PCN# 20260518001.1
Qualify MLA as an additional Assembly site for select devices
Change Notification / Sample Request

Date: May 19, 2026
To: MOUSER PCN

PCN Number:	20260518001.1	**PCN Date:**	May 19, 2026
Title:	Qualify MLA as an additional Assembly site for select devices		
Customer Contact:	Change Management team	**Dept:**	Quality Services
Proposed 1st Ship Date:	August 17, 2026	**Sample requests accepted until:**	July 18, 2026*

Qualification Results

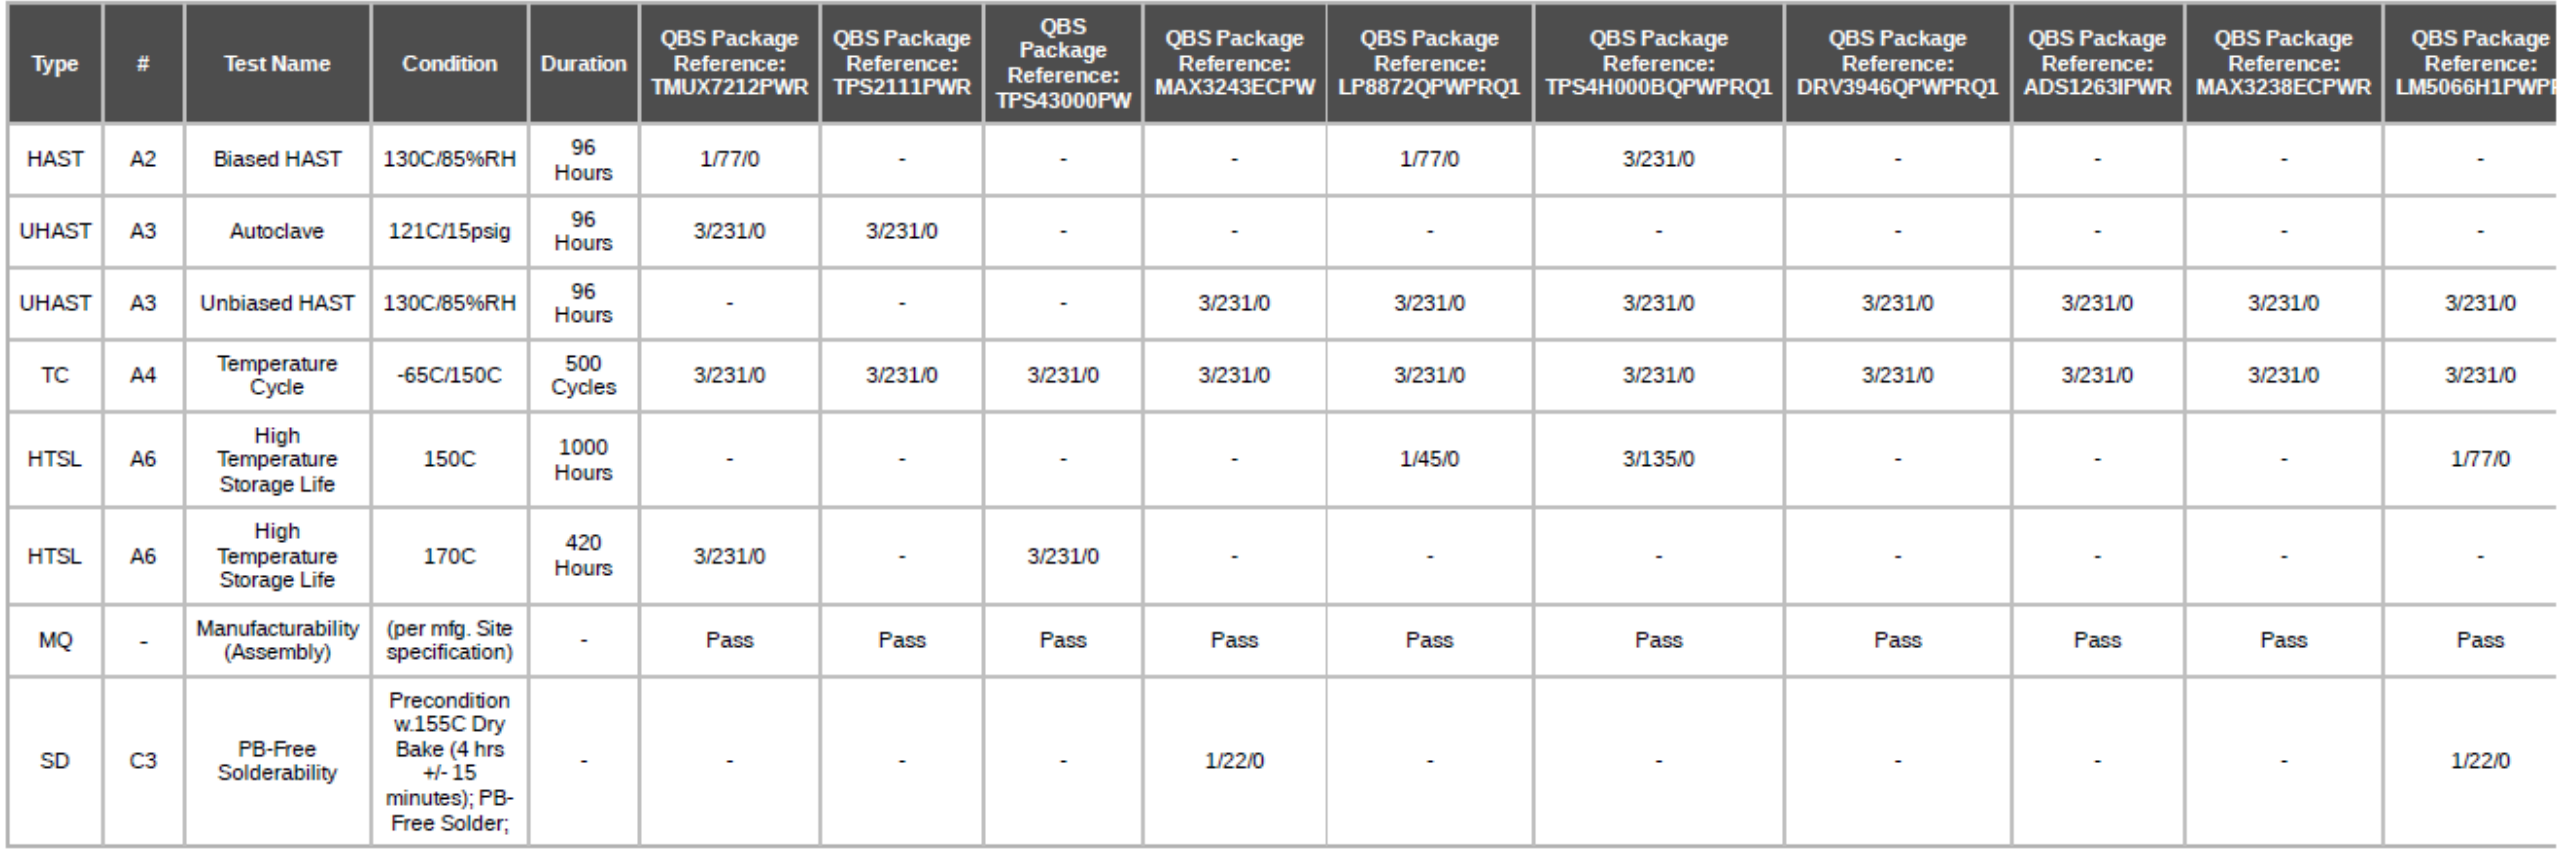
Data Displayed as: Number of lots / Total sample size / Total failed

The following are equivalent HTOL options based on an activation energy of 0.7eV : 125C/1k Hours, 140C/480 Hours, 150C/300 Hours, and 155C/240 Hours

The following are equivalent HTSL options based on an activation energy of 0.7eV : 150C/1k Hours, and 170C/420 Hours

The following are equivalent Temp Cycle options per JESD47 : -55C/125C/700 Cycles and -65C/150C/500 Cycles
